RENESAS TECHNICAL UPDATE

Product Category	MPU/MCU		Document No.	TN-SH7-A862A/E	Rev.	1.00
Title	The addition to the description of assertion/negation expanded cycle in MPX-I/O of the Bus State Controller (BSC)		Information Category	Technical Notification		
Applicable Product	SH7084 Group SH7085 Group SH7086 Group	Lot No.	Reference Document	SH7080 Group User's Manual: Hardware Rev.5.00(R01UH0198EJ0500)		
		ALL

We would like to inform you of addition to the description of assertion/negation expanded cycle in MPX-I/O of the Bus State Controller (BSC) in the applicable products.

Figure 9.11 (2) Access Timing for MPX Space
 (Address Cycle No WAIT, Assert Period Expansion 1.5, Data Cycle No Wait, Negation Period Expansion 1.5)

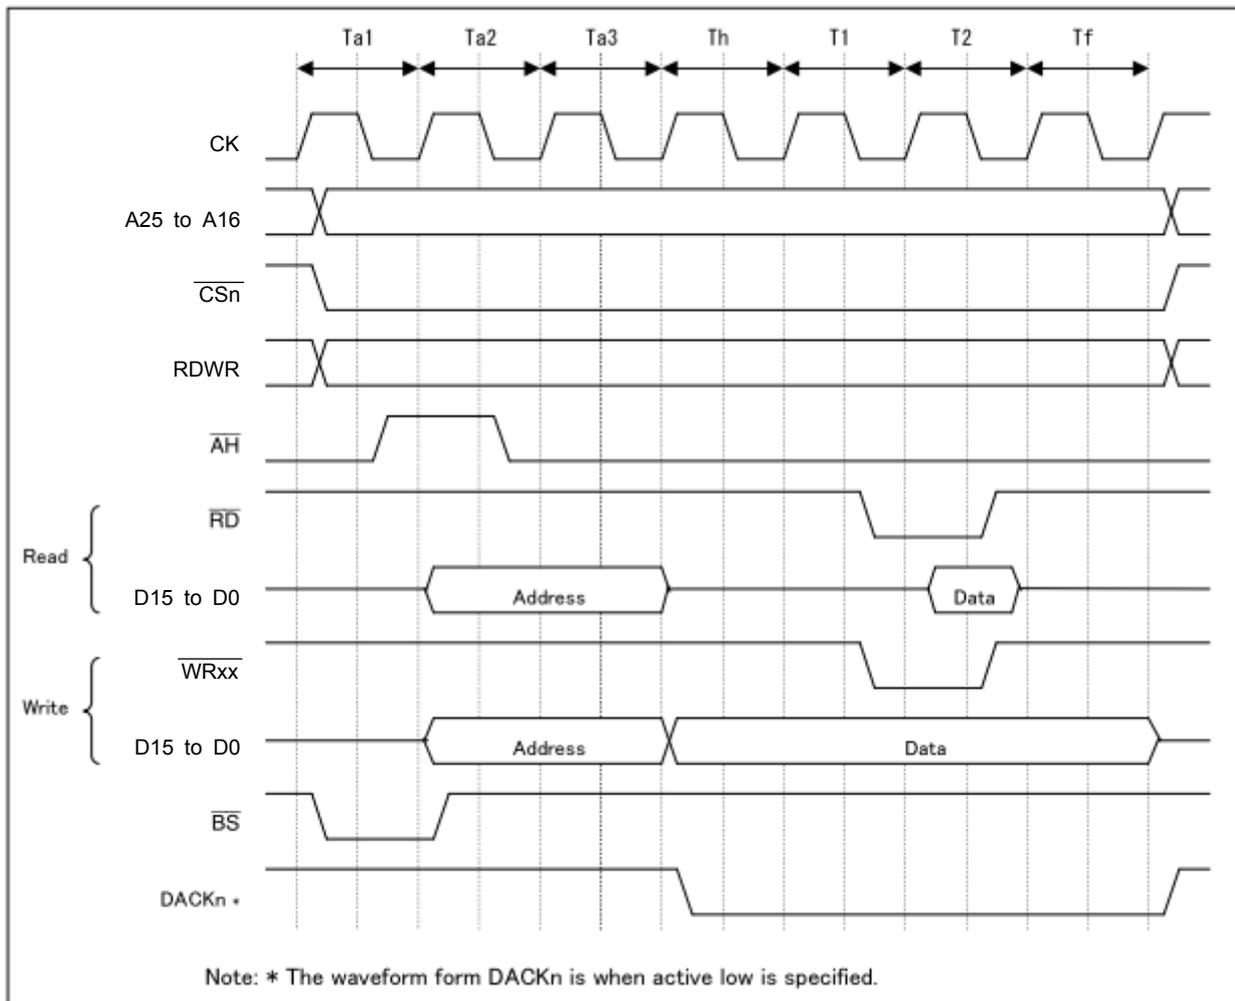
The data cycle is the same as that in a normal space access.
The delay cycle of SW[1:0] is inserted between Ta3 and T1 cycle.
The delay cycle of HW[1:0] is added after T2 cycle.
Timing charts are shown in figures 9.11 to 9.13.

[Addition]
